**SECTION 00 9121  
REBID ADDENDUM NUMBER 1**

**DATE: November 18, 2016**

**RSMP Phase 2A REBID**  
**James Monroe High School**  
**RFI LOG**  
11/17/16

PROJECT: **RSMP - JAMES MONROE HIGH SCHOOL  
PHASE 2A- REBID**

DRAWING NO.  
**C001**

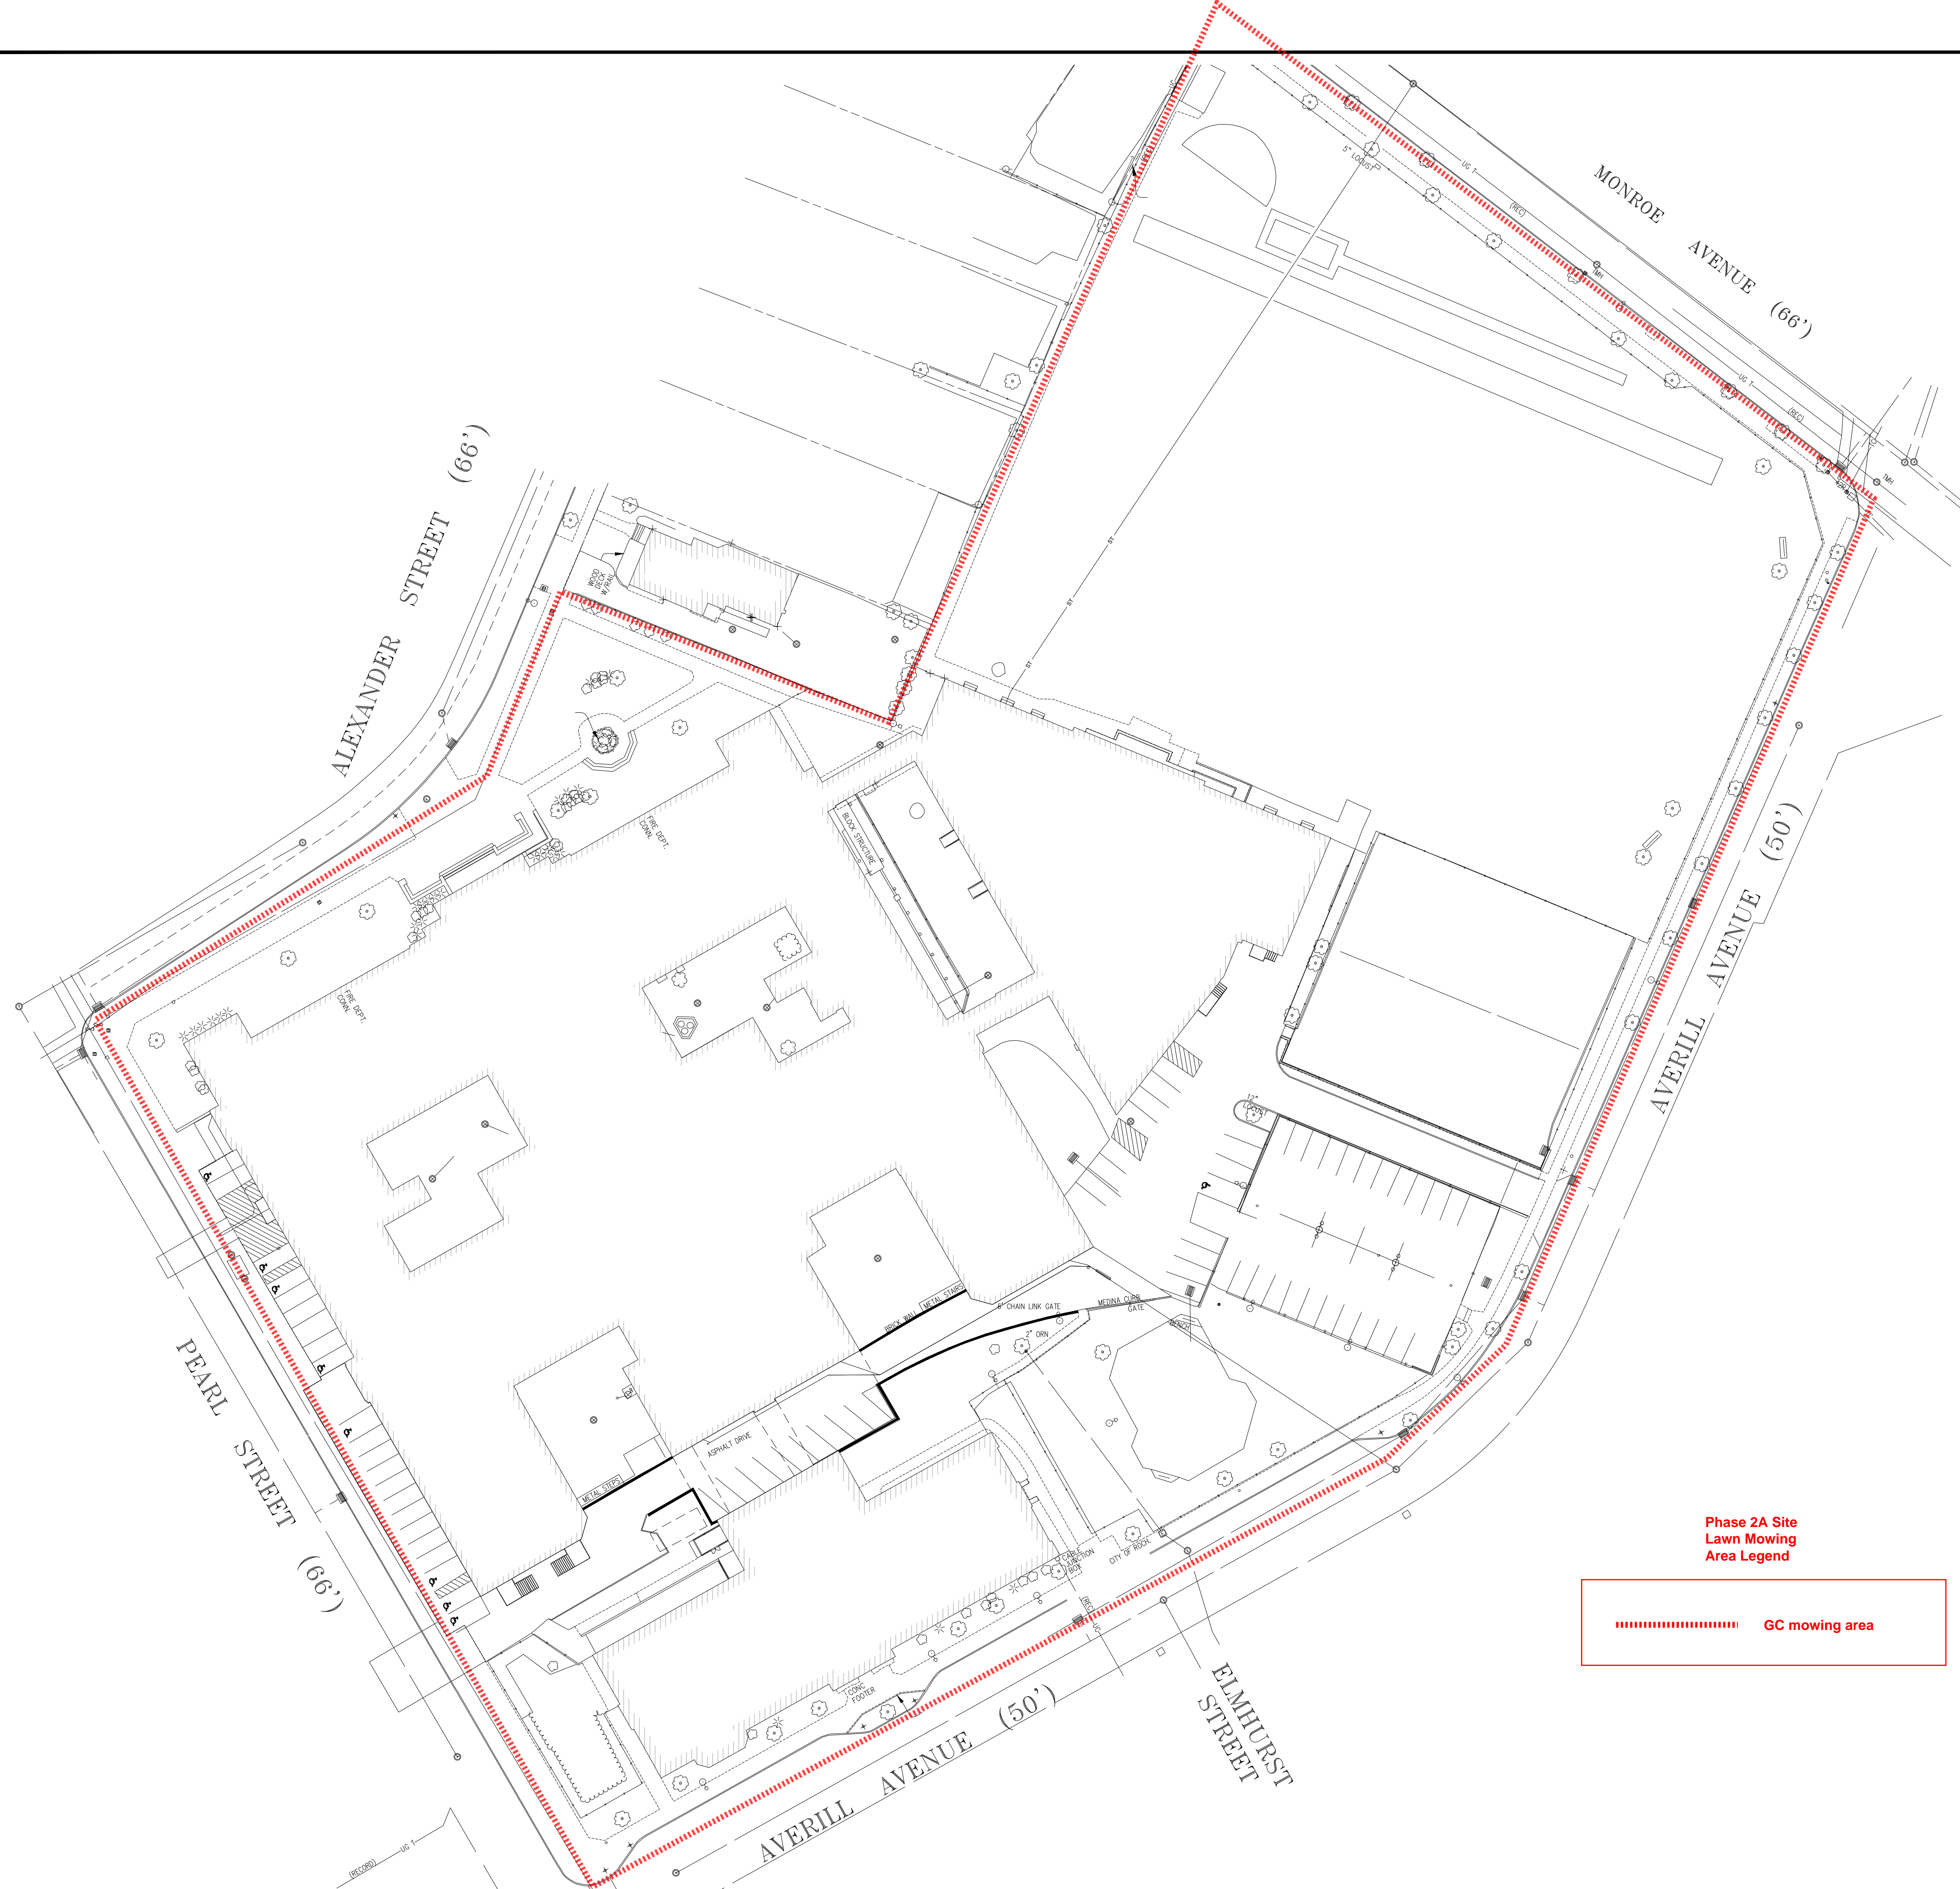
- A. **REPLACE** the black and white Sketch CM-01 GC Mowing Area with the attached color sketch CM-01 GC Mowing Area.

DRAWING NUMBER:  
**ADDSK-A-17**

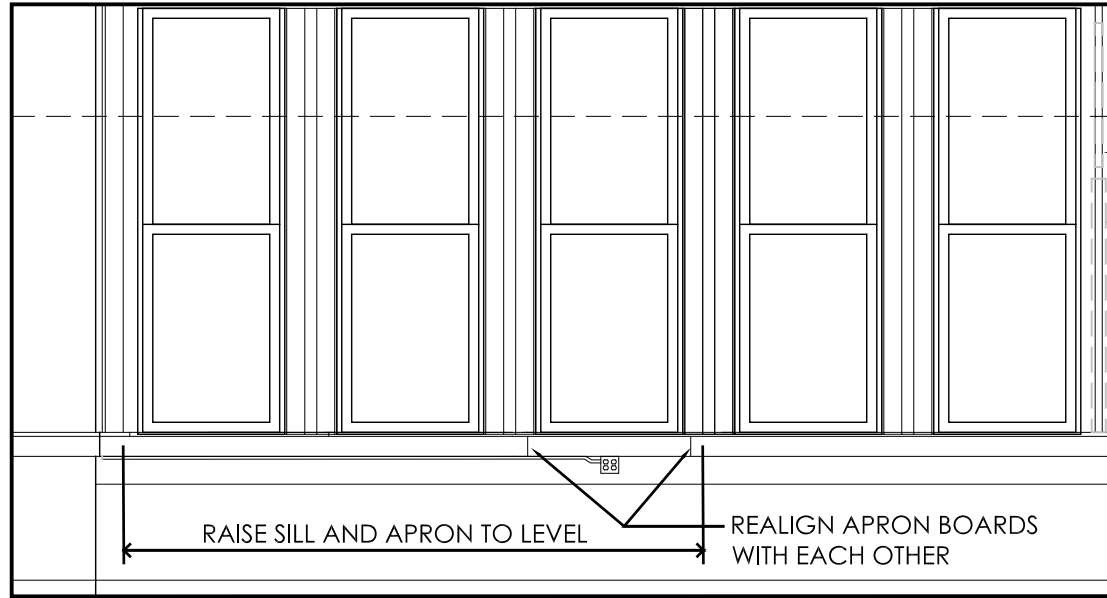
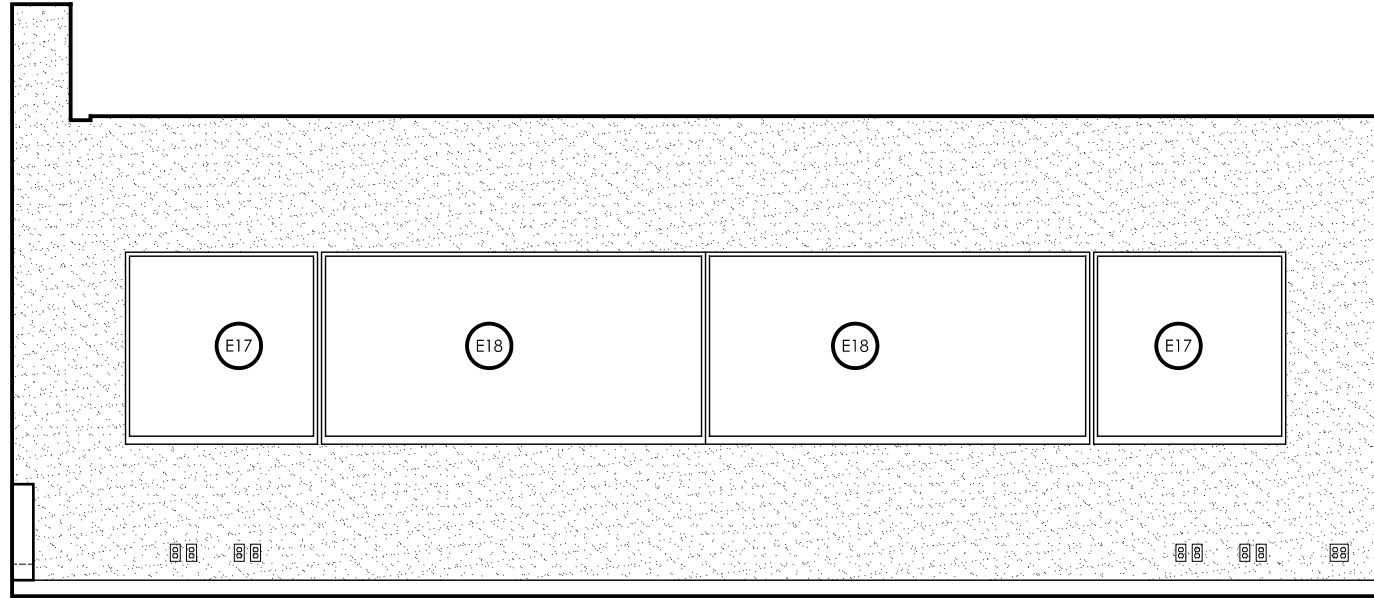
- A. Provide Stair 12A ceiling per ADDSK-A-17.

REMOVE WOOD NAILER AND STEEL CHANNEL AT FORMER AND NEW PARTITION LOCATION.

2 ROOM 125  
SCALE: 1/4" = 1'-0"

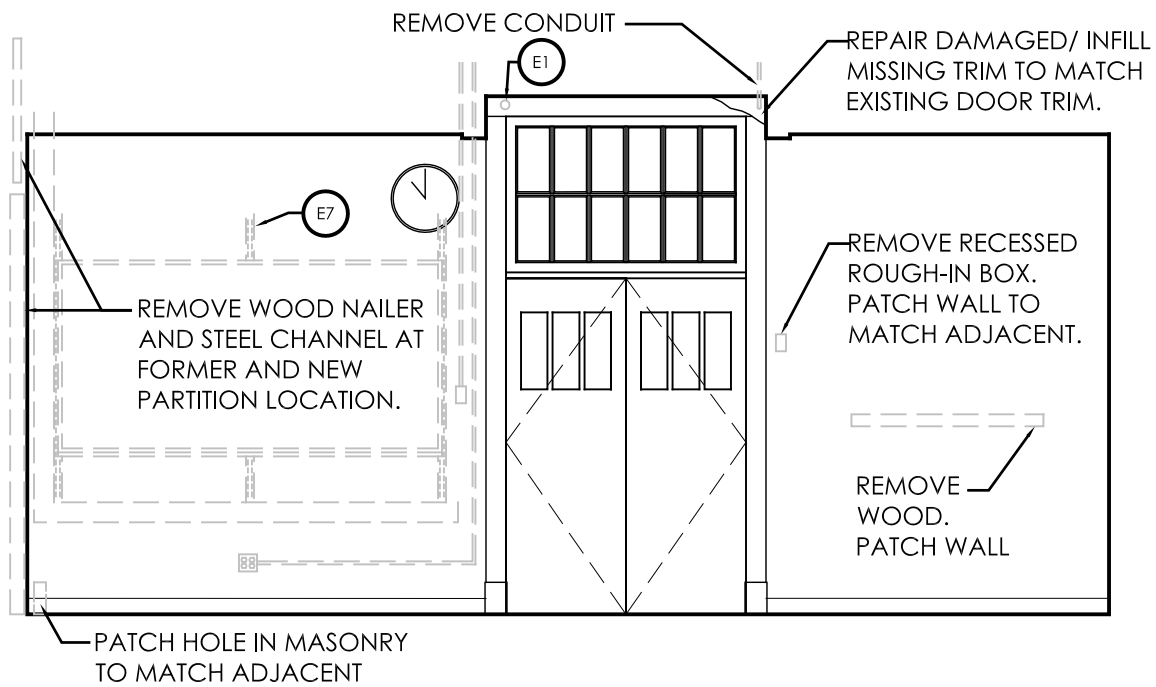
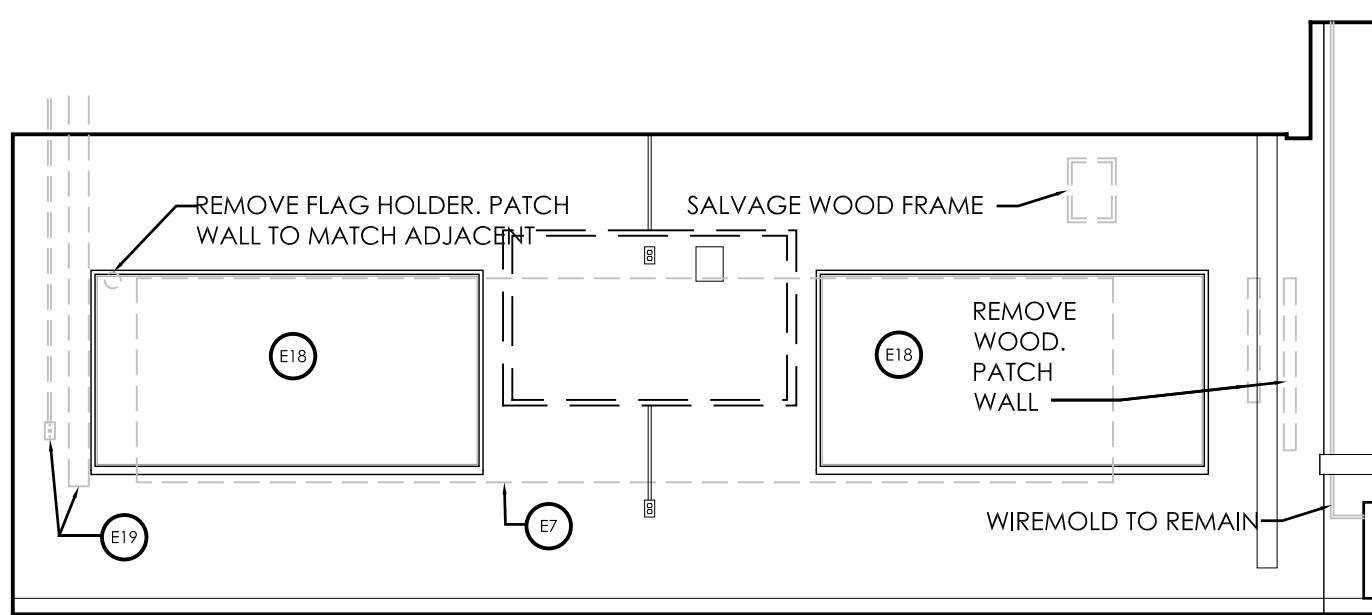
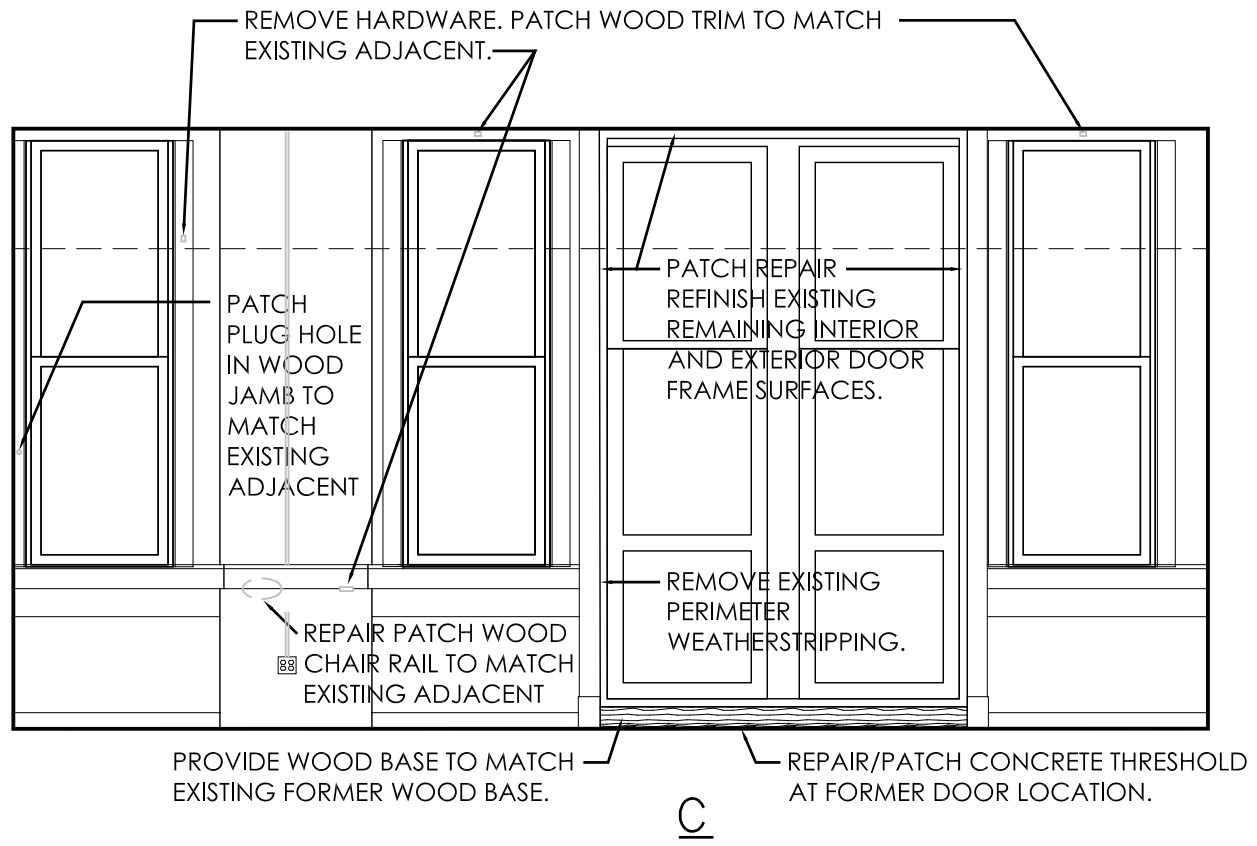
- A. Replace room elevations 2/A308 and 3/A308 for rooms 125 and 126 with the attached sketches ADDSK-A-18 and ADDSK-A-19 respectively.

**7** MAIN ENTRANCE AND STAIR SNOW MELT SYSTEM  
 A204 SCALE: 1/8" = 1'-0"

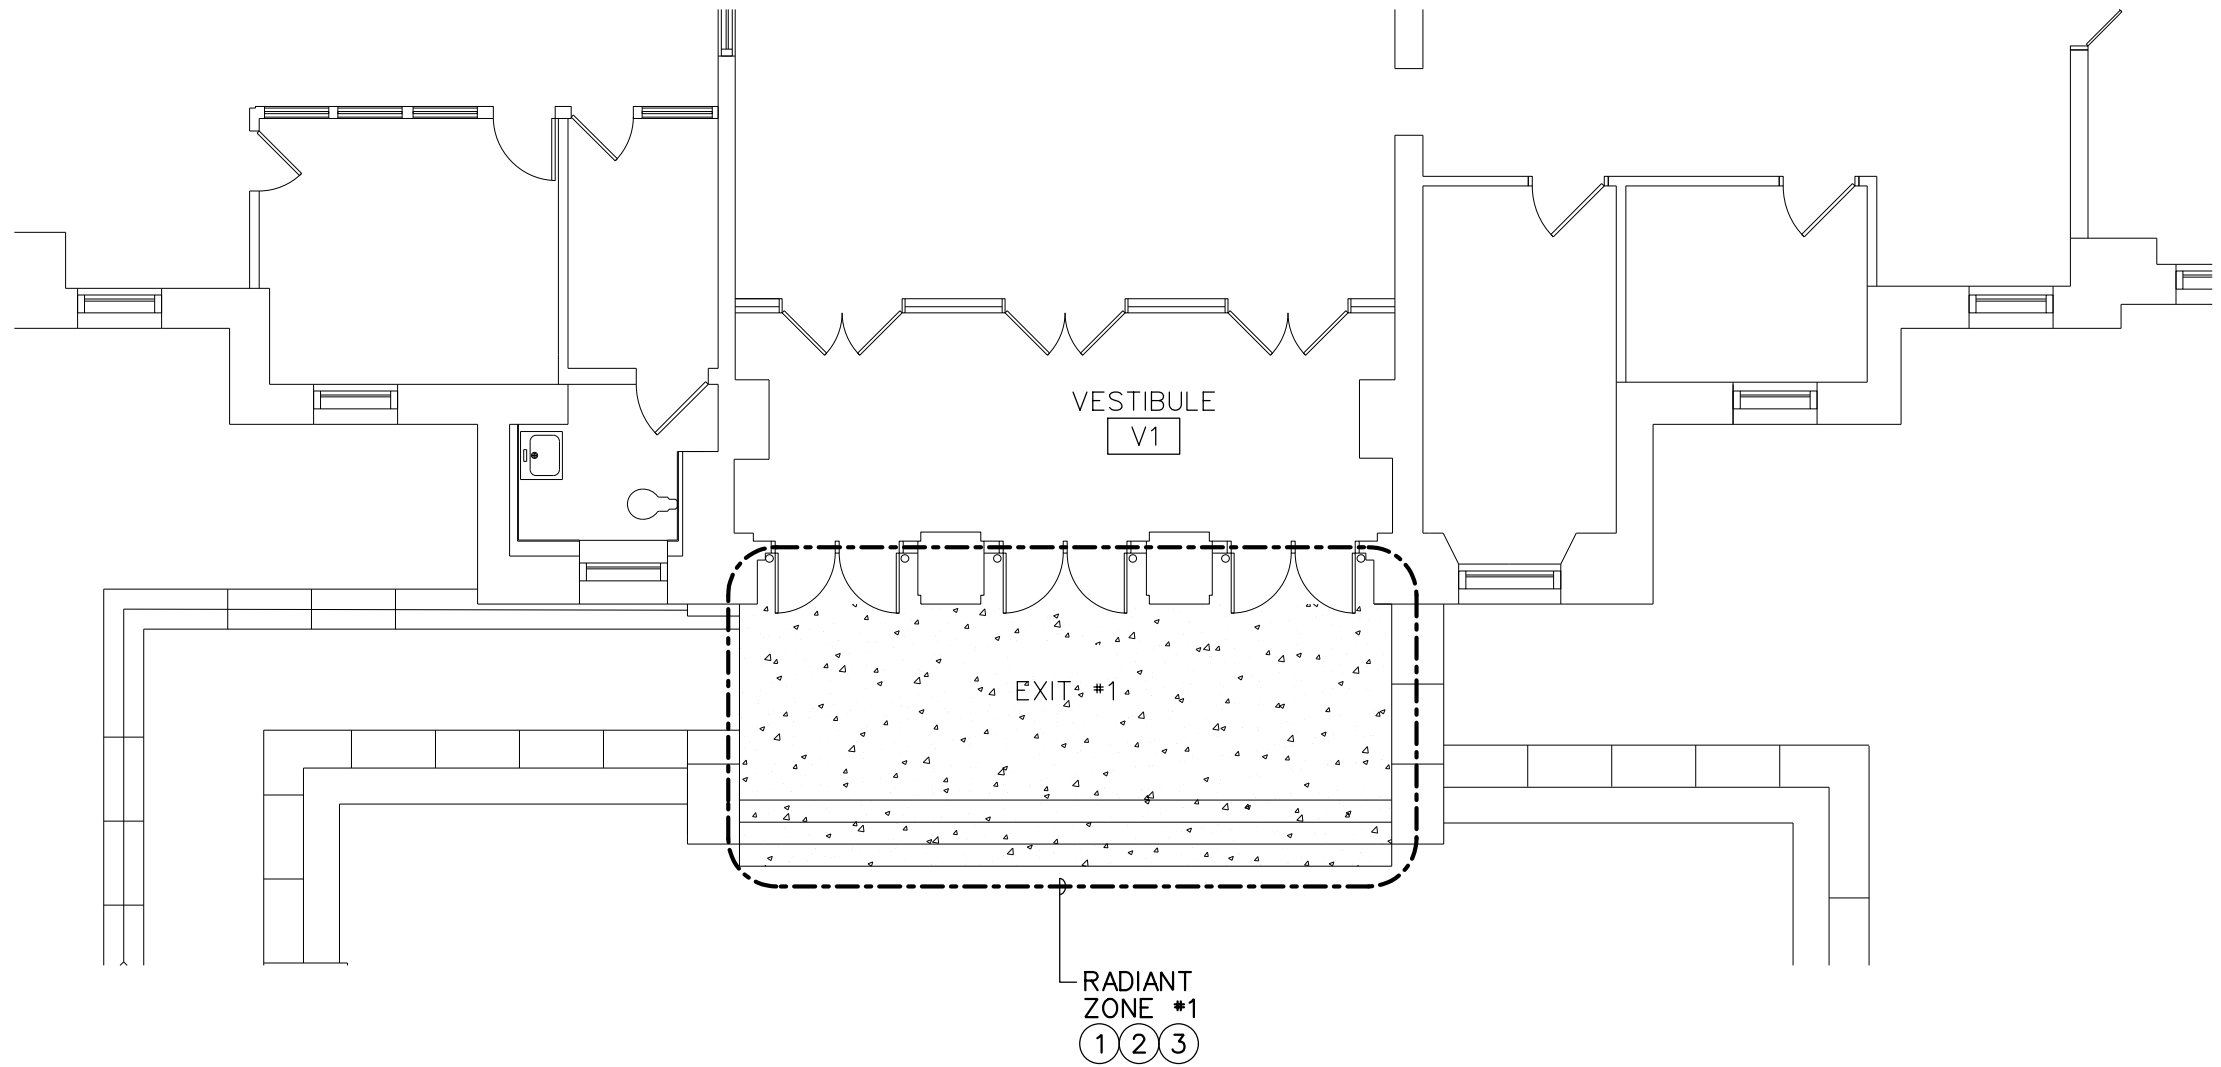
- A. Provide a snow melt system to the entrance landing and steps per ADDSK-A-21.

A. THIS CONCEPT OF THIS SKETCH IS TO ADD RADIANT TUBING TO THE MAIN ENTRANCE AND STEPS.

- ① PROVIDE RADIANT SNOW MELT TUBING IN THE MAIN ENTRANCE LANDING AND STAIRS.
- ② THE TUBING SHALL BE INSTALLED AND TERMINATED AT THE MANIFOLD IN THE CRAWL SPACE BELOW. LOCATE THE MANIFOLD IN CRAWL SPACE CS, REFER TO DRAWING LS100 FOR CLARIFICATION. SYSTEM TO BE CAPPED FOR FUTURE CONNECTION TO THE BUILDING HEATING SYSTEM.
- ③ PROVIDE A 1" CONDUIT IN THE SLAB FOR INSTALLATION OF THE SLAB MOUNTED CONTROL SENSOR. THE CONDUIT SHALL TERMINATE IN CRAWL SPACE CS, ADJACENT TO THE MANIFOLD. COORDINATE WITH DAY AUTOMATION FOR LOCATION OF THE SLAB SENSOR.

RADIANT SNOW MELT SLAB SCHEDULE											
ZONE NO.	AREA SERVED	SUPPLY WATER TEMP DEG F	PRIMARY AREA (SQ.FT.)	GPM	P.D. FT HD	MBH	TUBING SIZE	MAX TUBING SPACING	NO. OF CIRCUITS	CIRCUIT LENGTH FT	DESIGN EQUIPMENT
1	EXIT #1 AND STAIRS	101	420	6.7	5.7	60.7	5/8"	9"	4	175	WATTS RADIANTPEX
